RE: Modifications to Niagara Region Wind Farm (Addendum 2)

The addendum report proposes relocation (<10m shift from original proposed location) of turbines 18, 32 and 35. Upon review of the addendum report, MNR is satisfied that the Natural Heritage Assessment requirements of Ontario Regulation 359/09 have been met.

Reference: Niagara Region Wind Farm NHA/EIS Addendum for Relocating Turbines T18, T32 and T35

Figure No.
 1

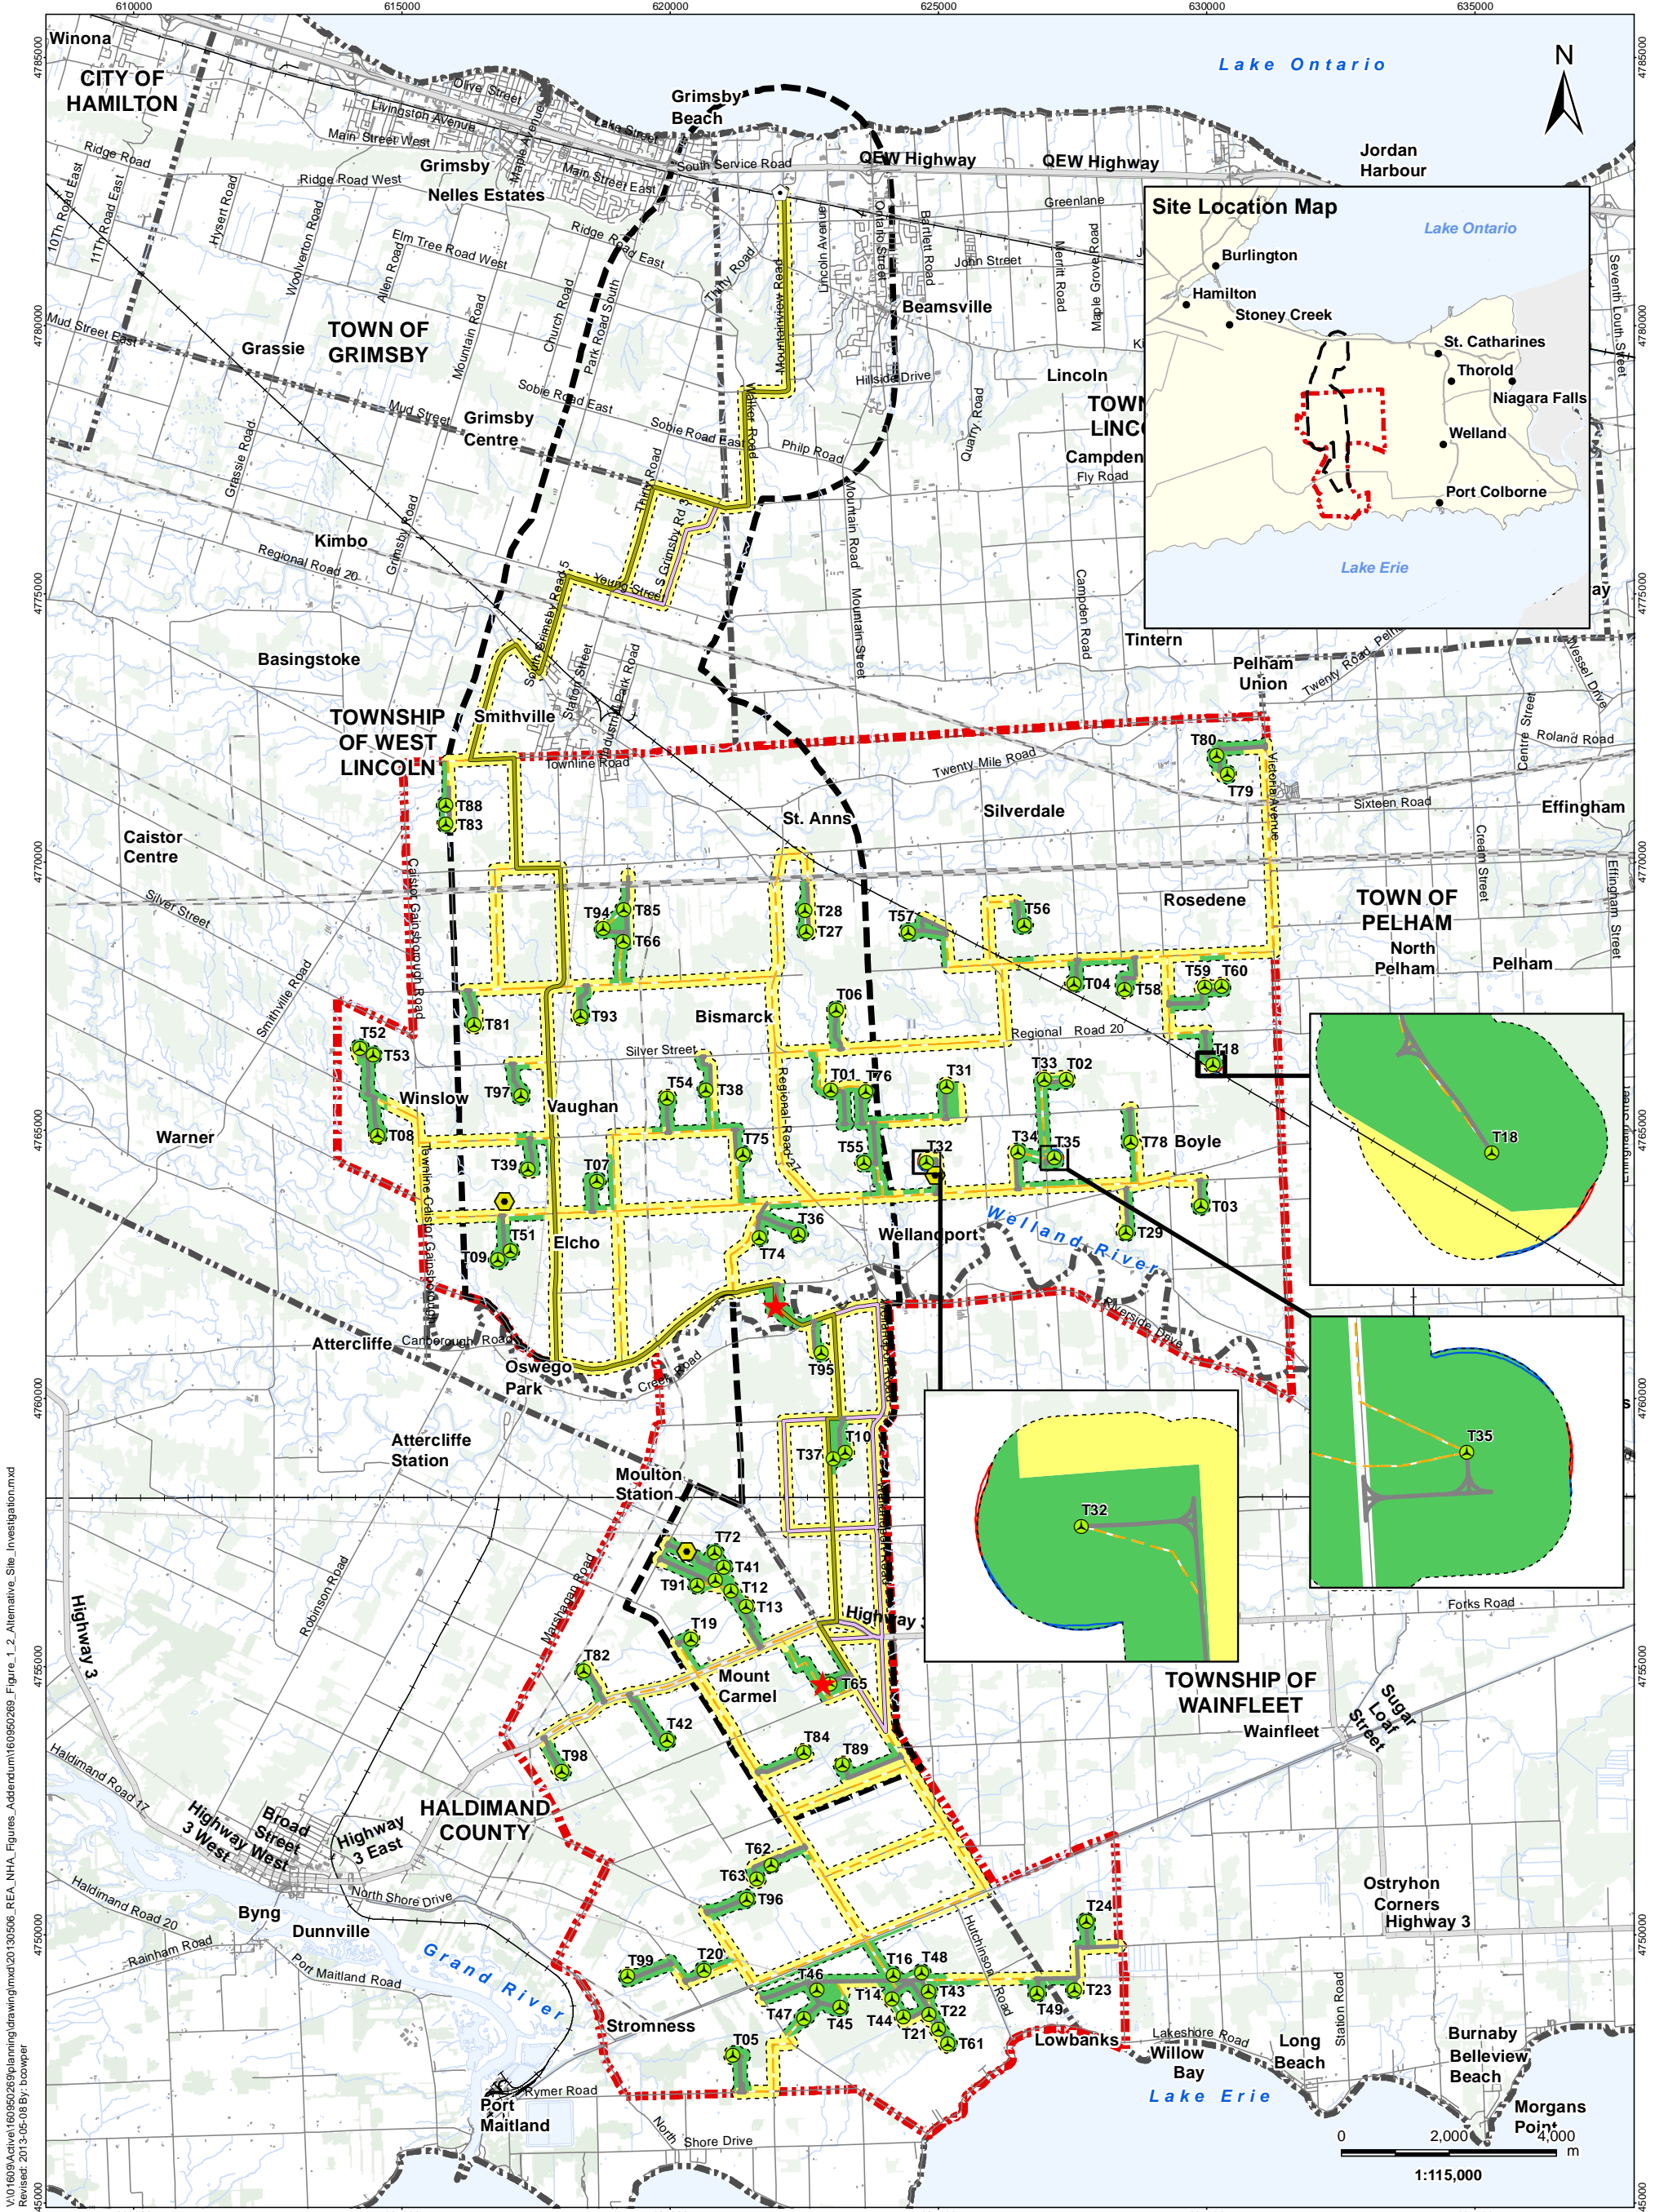
The records review included in the NHA/EIS, which was completed in accordance with Section 25 of O. Reg. 359/09, included the entire Study Area (see Revised **Figure 1.1**), which encompasses the minor adjustments to the location of these 3 turbines. No additional records or natural features were identified within the expanded zones of investigation as a result of the minor adjustment to these 3 turbine locations.

Figure No.
2.17

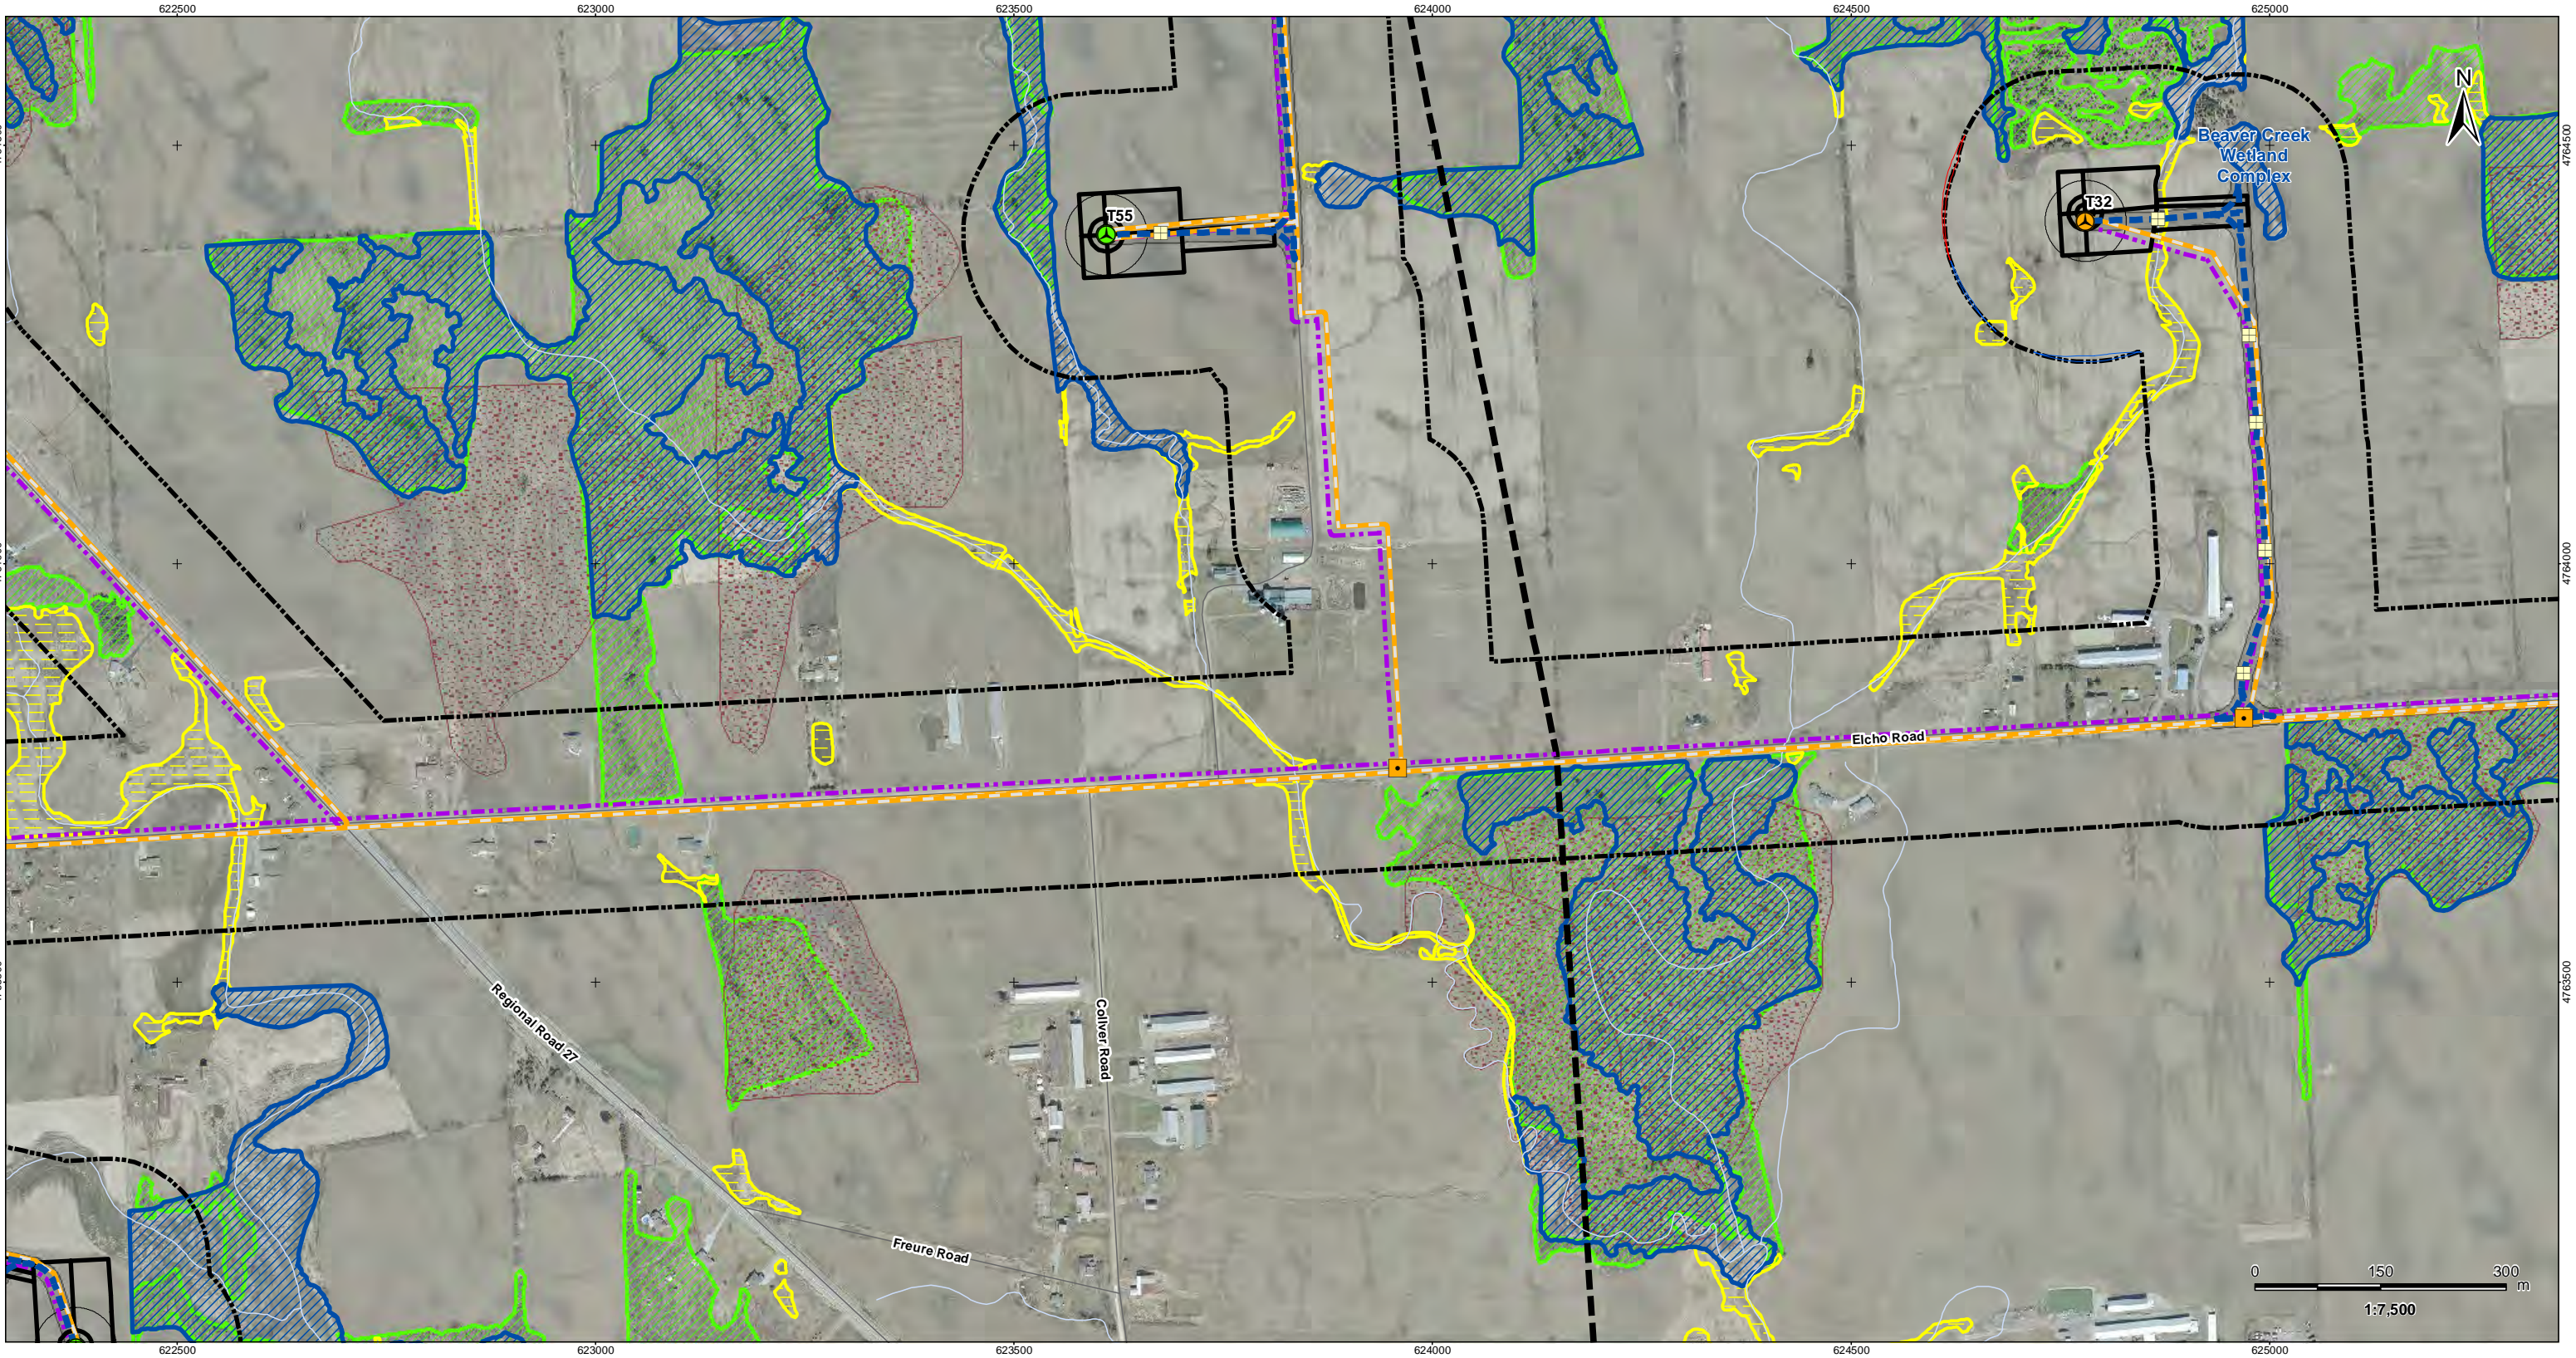
The NHA identified the Hwy 20 & 24 Wetland Complex, an MNR identified woodland and a deer wintering yard within the original zone of investigation. The expanded zone of investigation consists of an agricultural field. No additional natural heritage features were identified as part of the Records Review within the revised zone of investigation. (Revised **Figure 2.17**)

Figure No.
 2.29

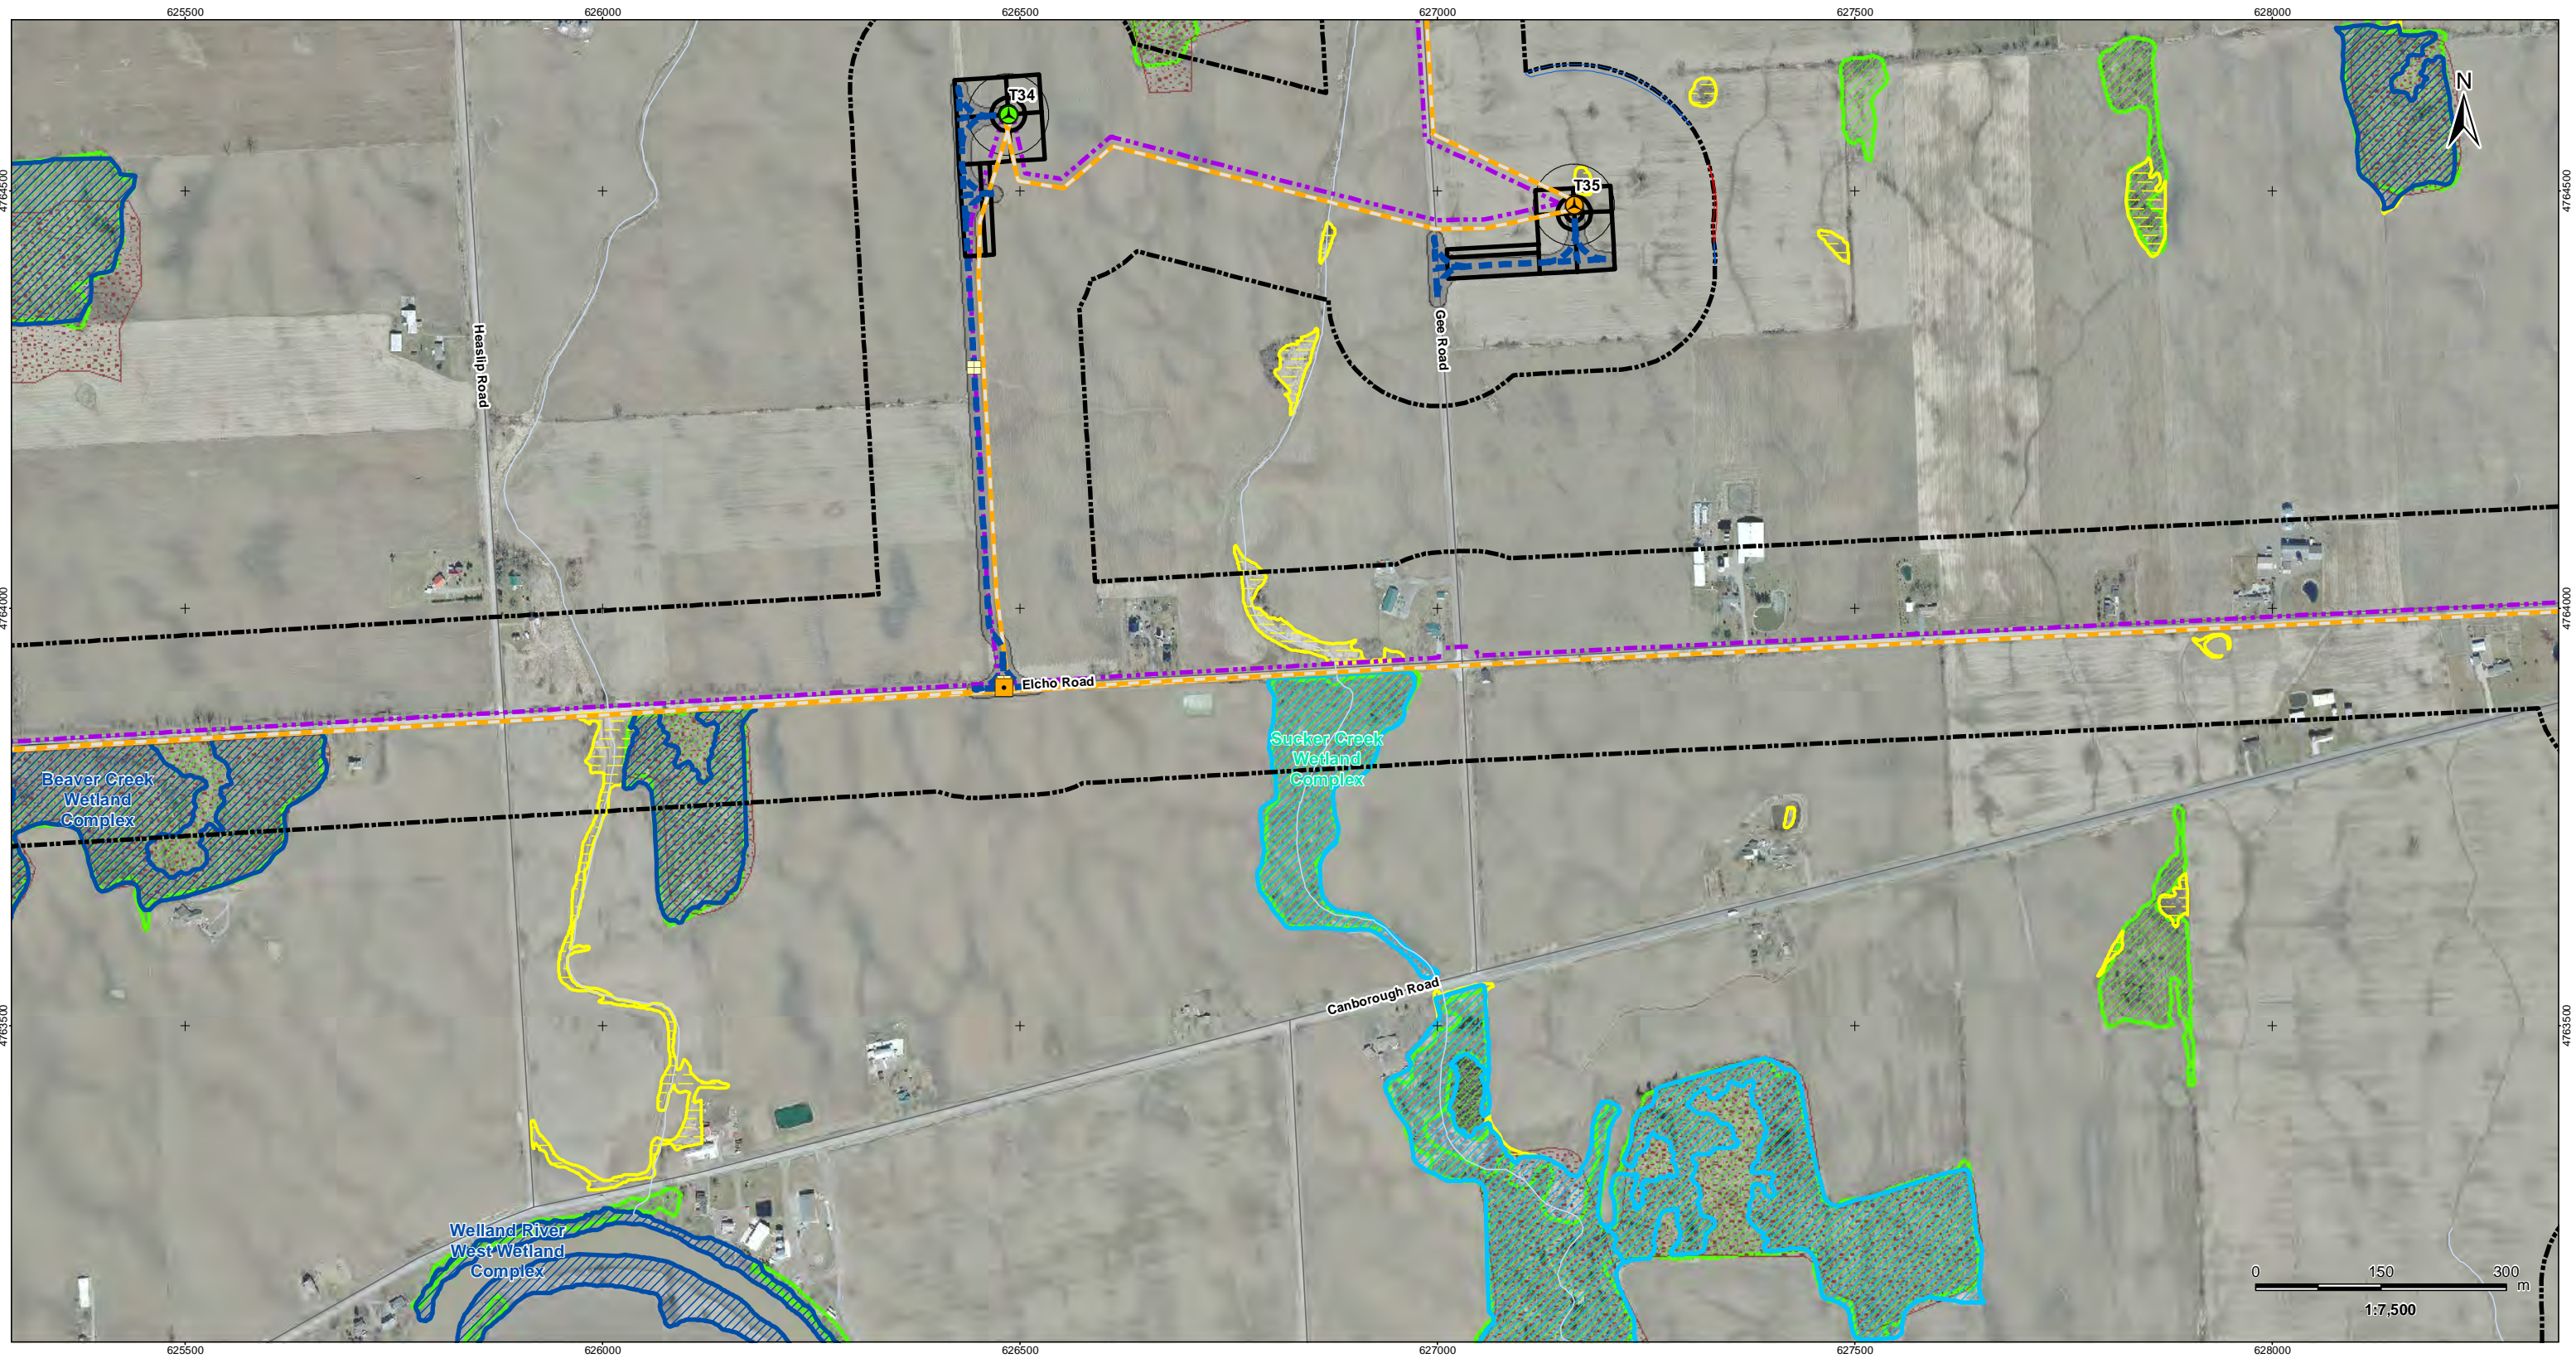
The NHA identified the Beaver Creek Wetland Complex, an unevaluated wetland identified by the NPCA and an MNR identified woodland within the original zone of investigation. The expanded zone of investigation consists of an agricultural field. No additional natural heritage features were identified as part of the Records Review within the revised zone of investigation (Revised **Figure 2.29**).
